Rosefield Solar Farm

Chapter 13: Noise and Vibration Figures

APFP Regulation Reg 5(2)(a)
Planning Act 2008
Infrastructure Planning
(Applications: Prescribed Forms
and Procedure) Regulations 2009
EN010158/APP/6.3.4
Revision 4
Deadline 3
May 2026
Rosefield Energyfarm Limited

TITLE: FIGURE 13.3 OPERATIONAL
 PHASE NOISE CONTOURS
 (WITHOUT ADDITIONAL MITIGATION)

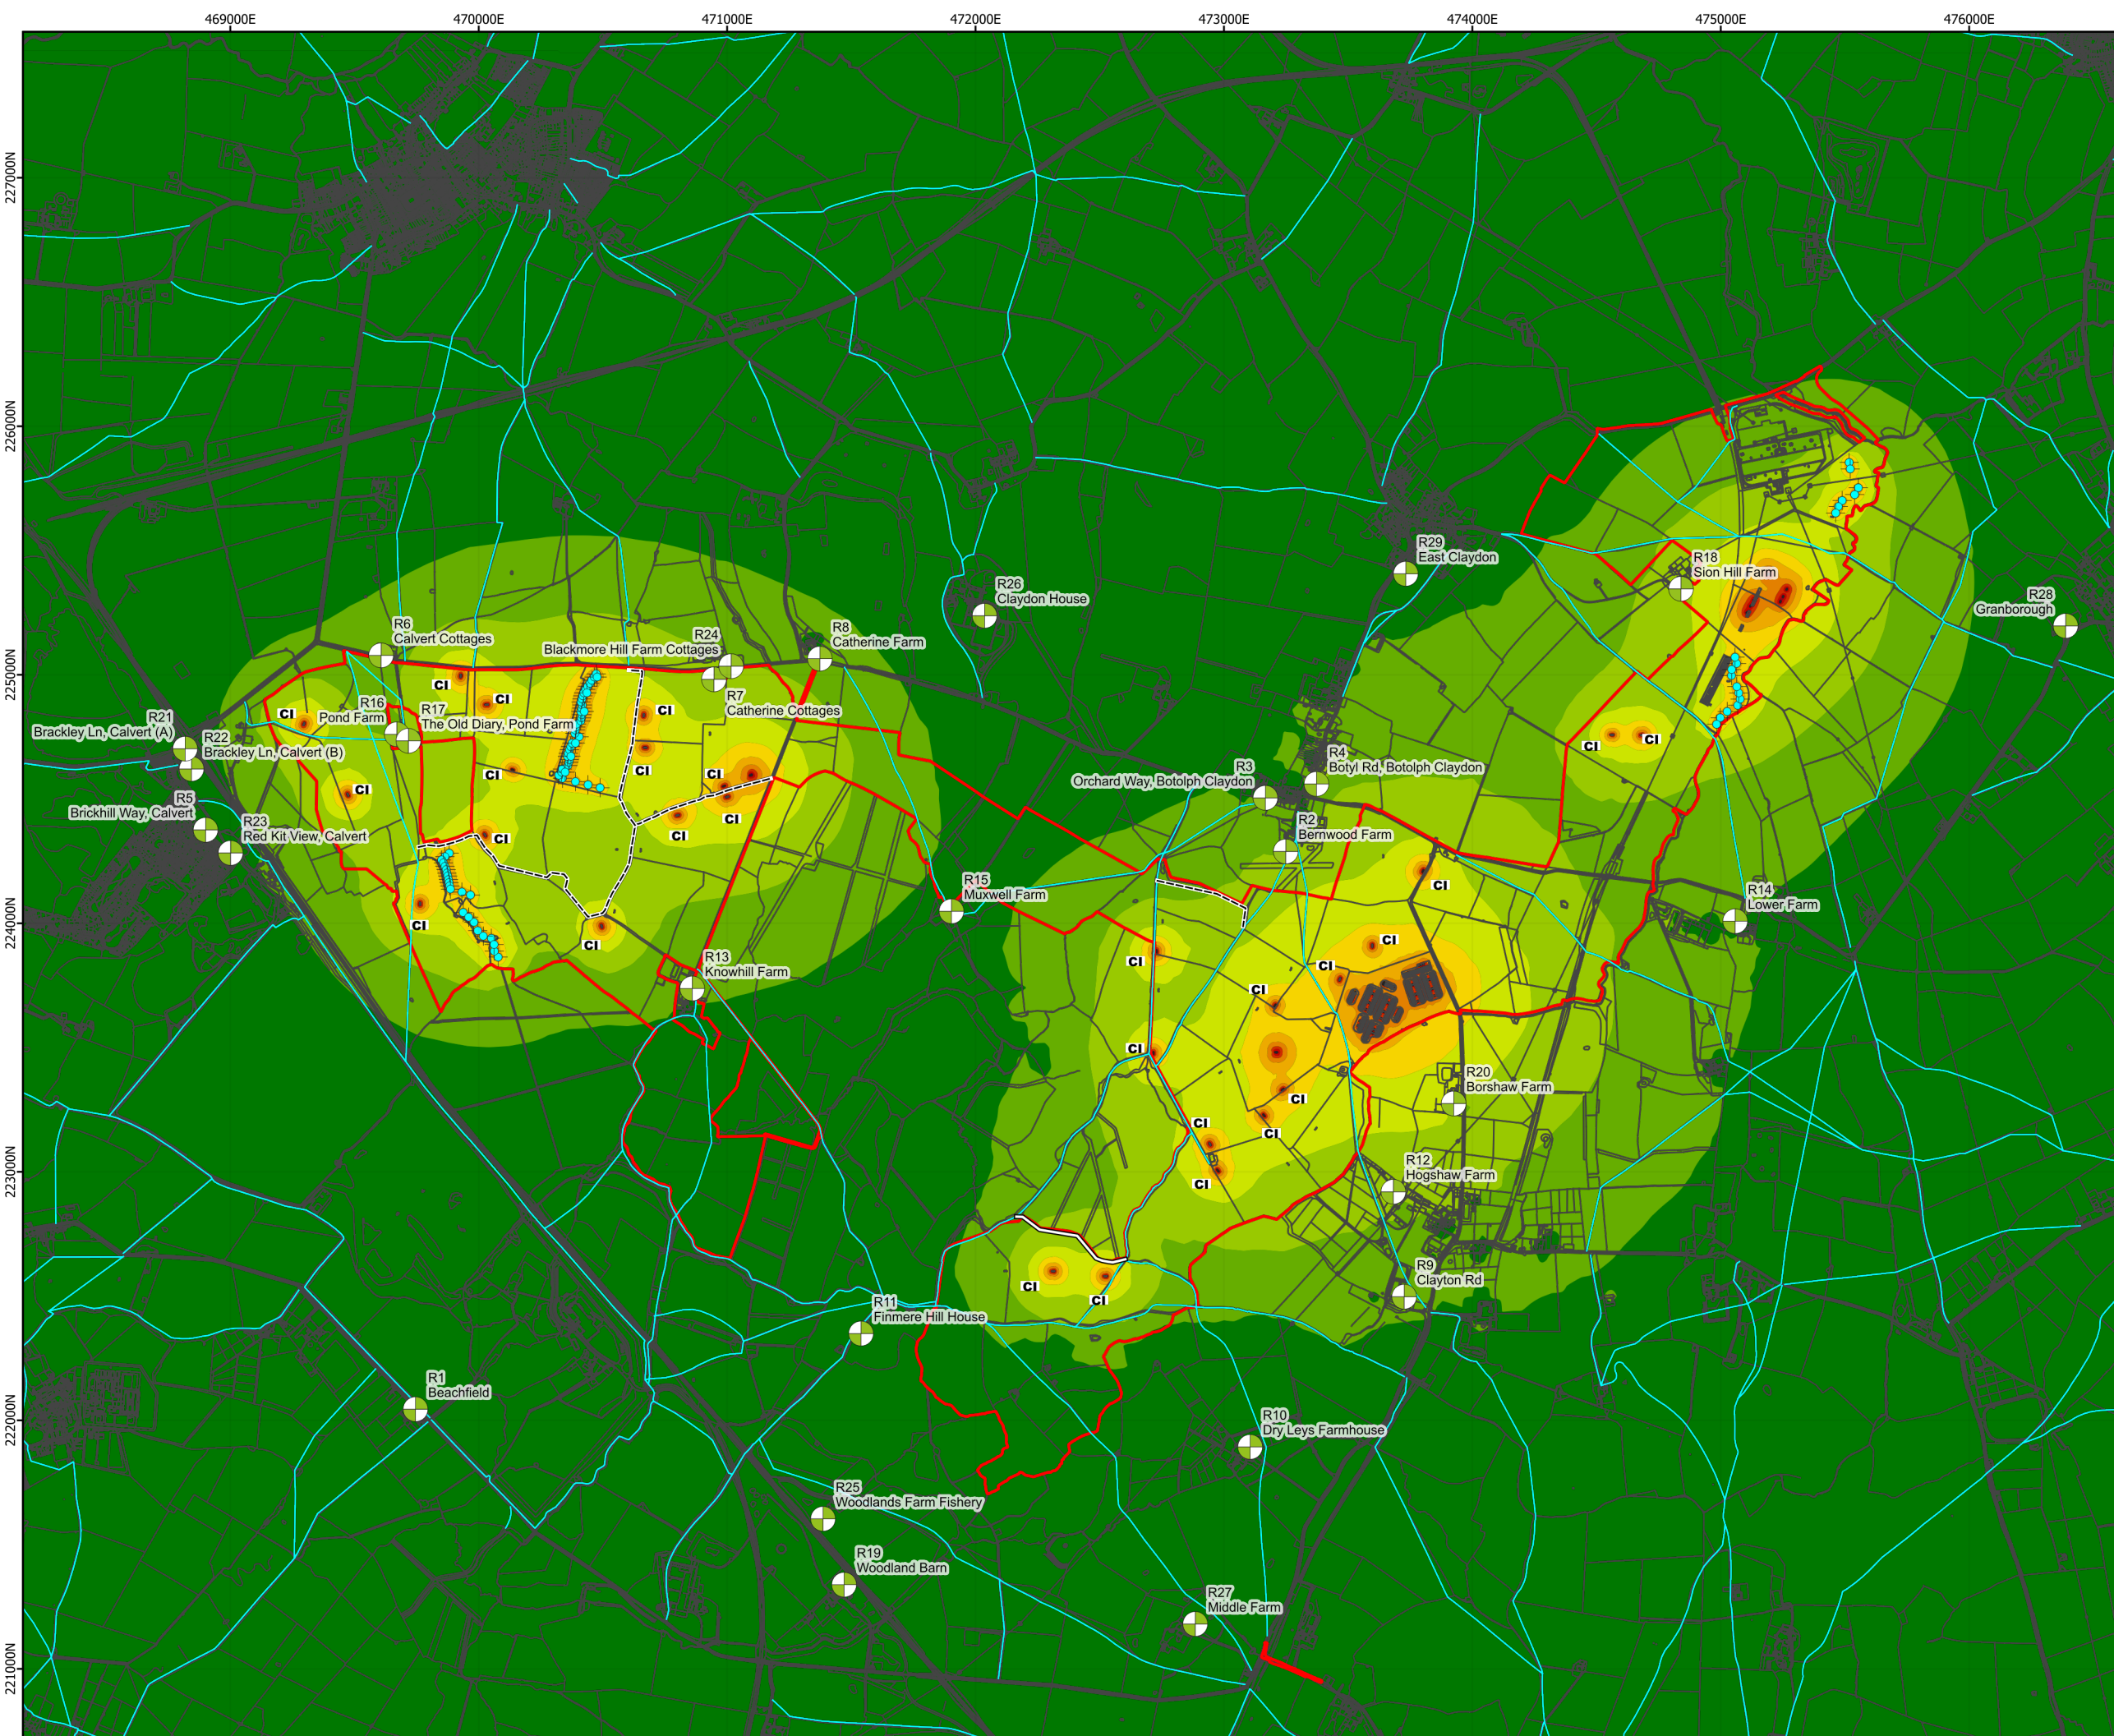
Drawing number	Revision number	Drawing title	Scale	Reason for revision
13.1	02	Study Area and Receptors	1:30,000 @ A3	No change made
13.2	01	Baseline Survey Locations	1:30,000 @ A3	No change made
13.3	03	Operational Phase Noise Contours (without additional mitigation)	1:25,000 @ A3	Updated to show the central inverters.
13.4	03	Operational Phase Noise Contours (with additional mitigation)	1:25,000 @ A3	Updated to show the central inverters.
